WATERBURY FILING NO. 1

CONSTRUCTION SET

GRADING AND EROSION CONTROL PLAN

WATERBURY FILING NO. 1	
CONSTRUCTION SET POND 3 DETAILS	
DESIGNED BY DLF	DRAWN BY QNA
CHECKED BY QNA	H-SCALE NA
V-SCALE N/A	JOB NO. 1715.00
DATE ISSUED 2/6/23	SHEET NO. 38 OF 39

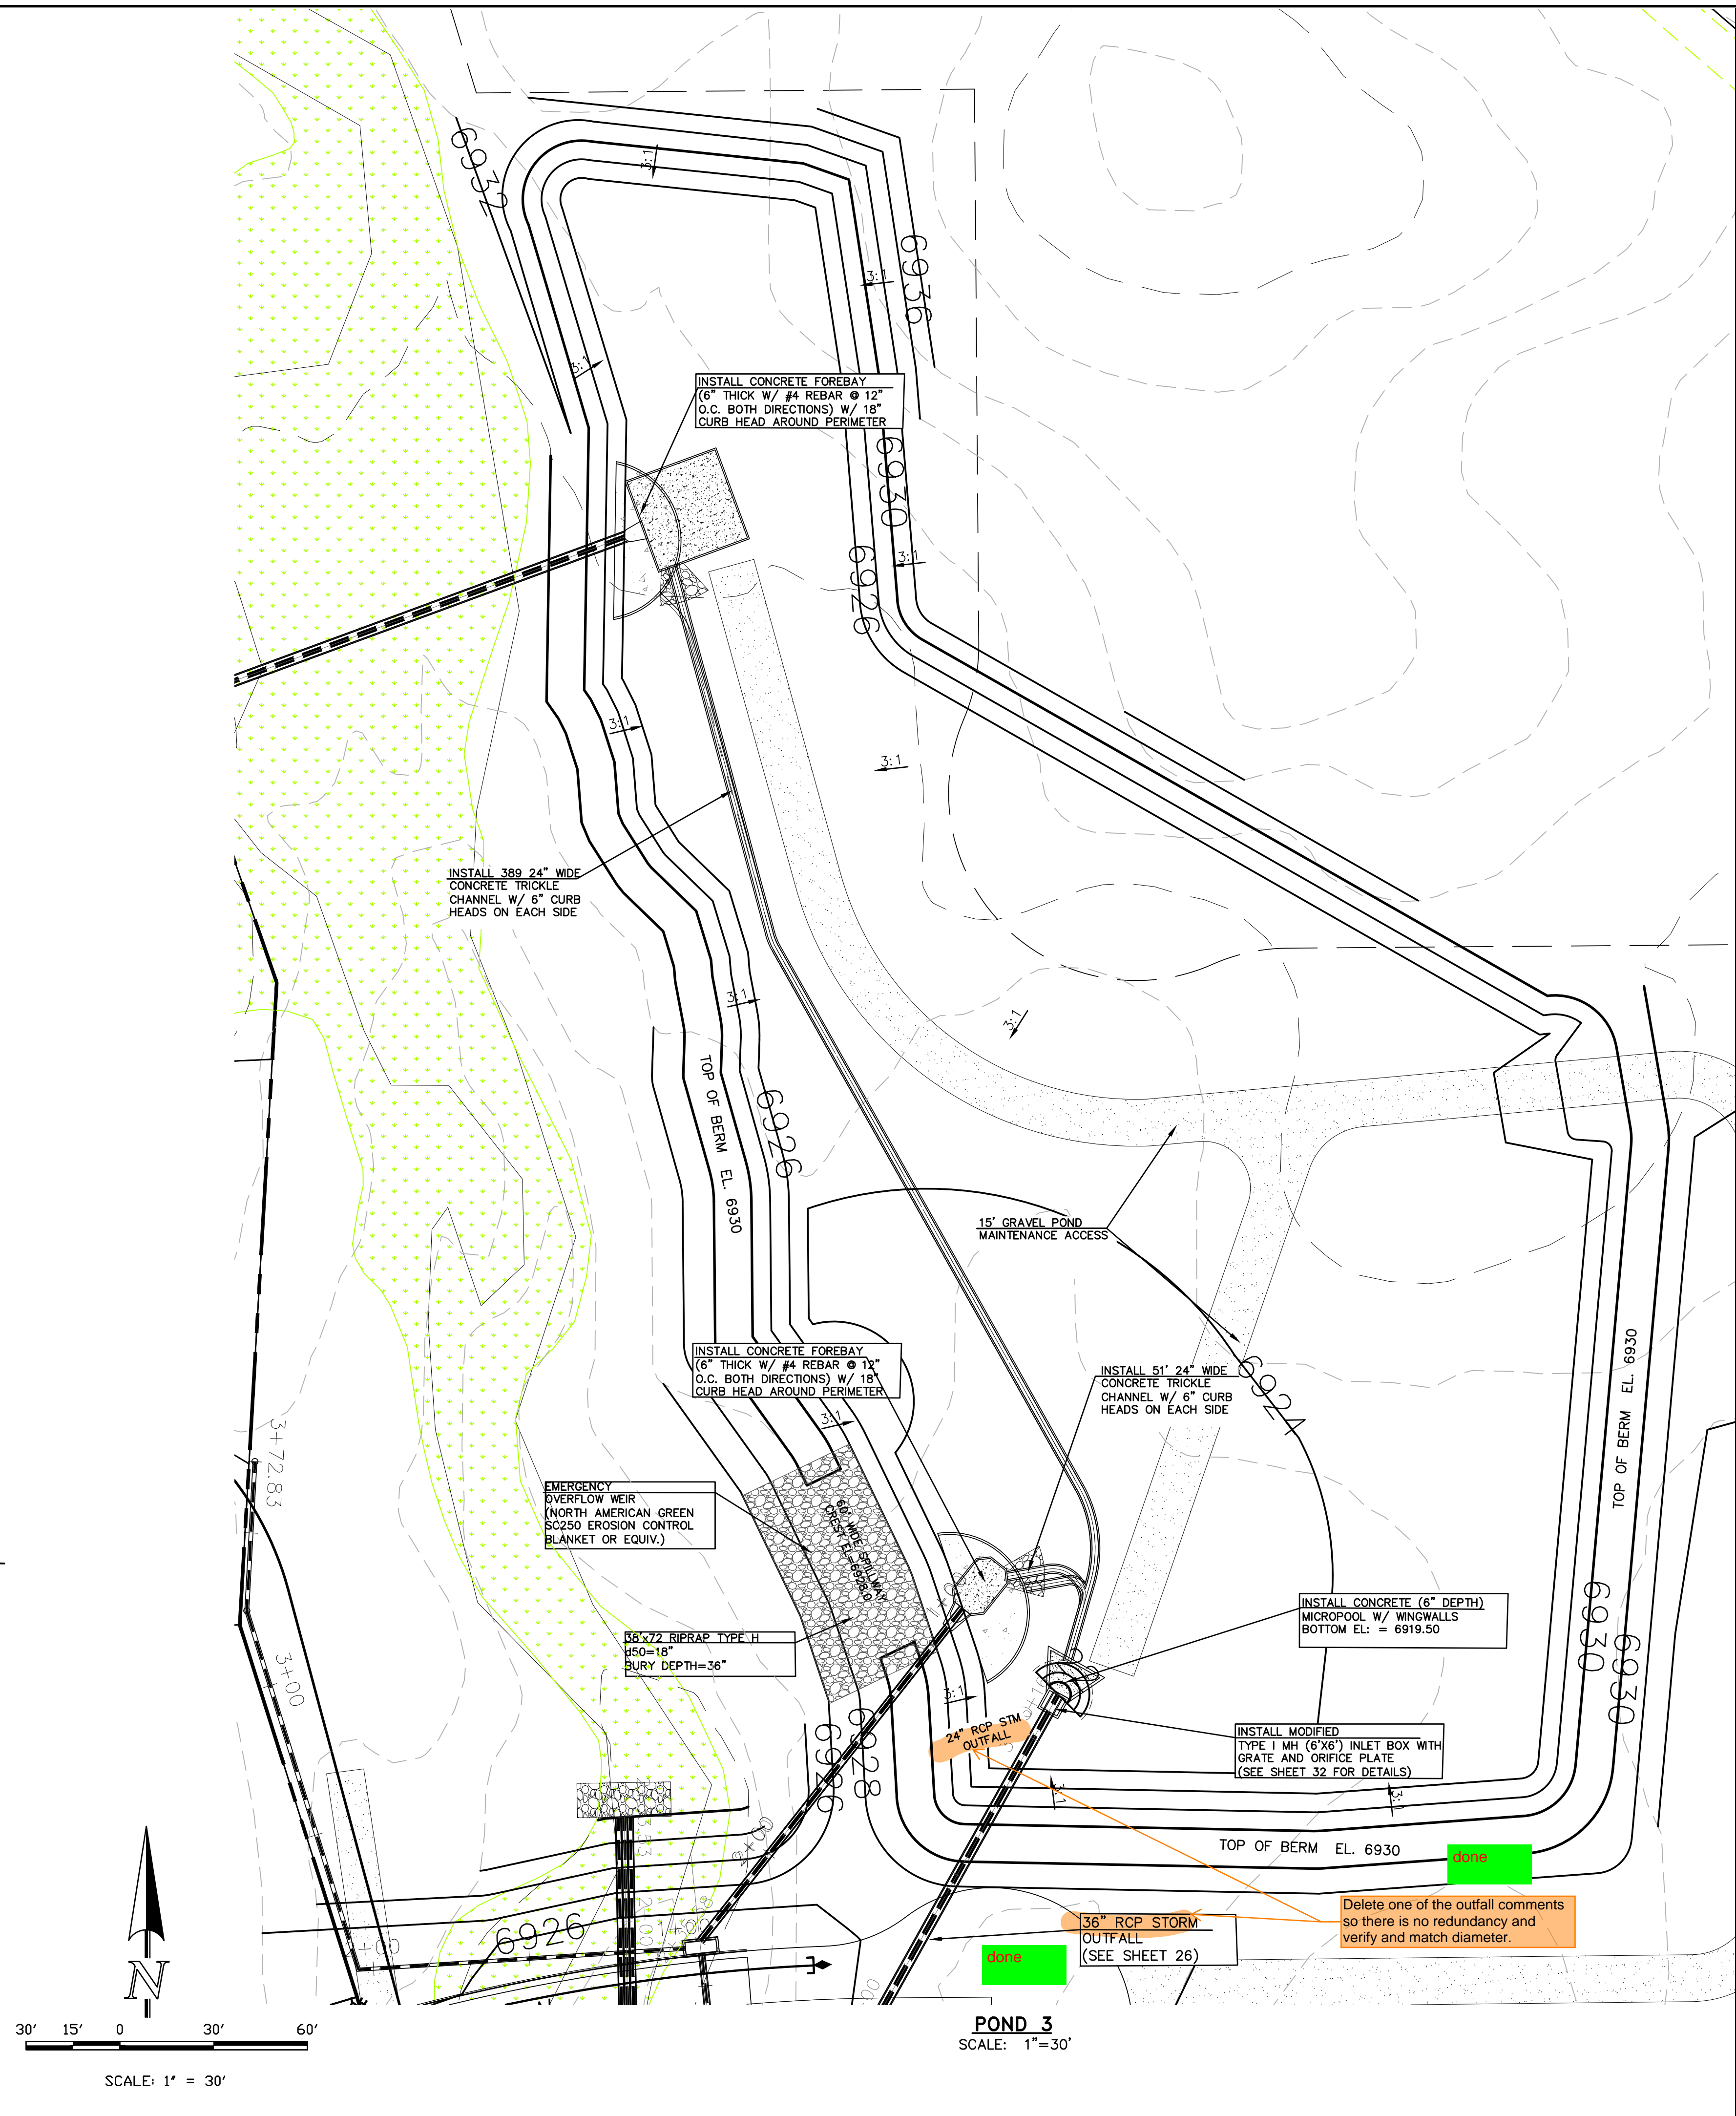
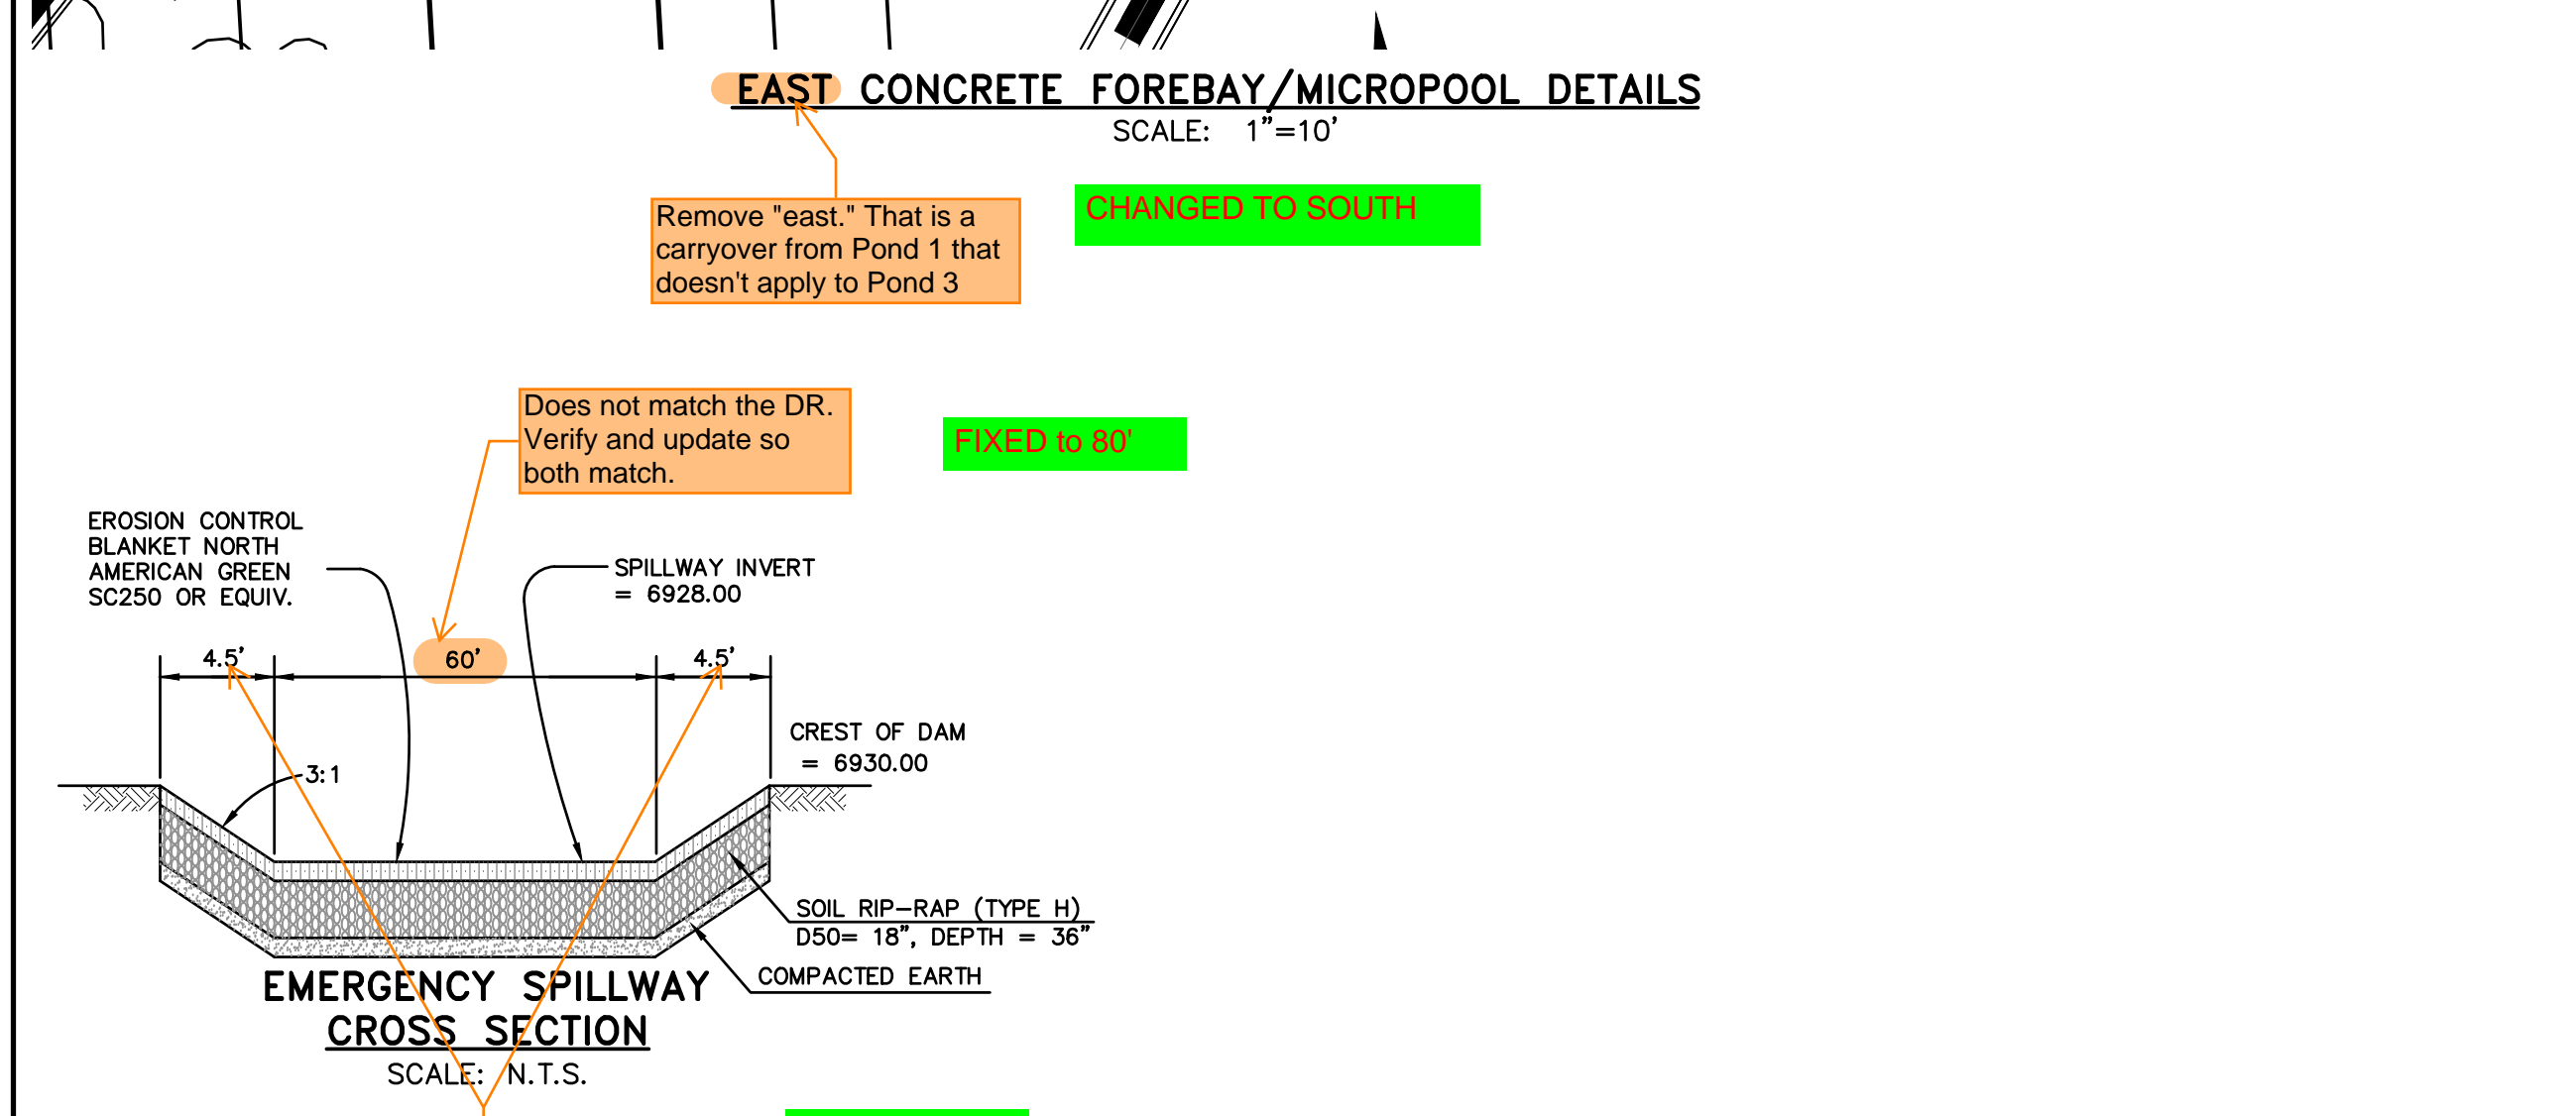
Does not match detail below or what is shown in DR calcs. Revise to remove discrepancy.

Does not match the DR. Verify and update so both match.
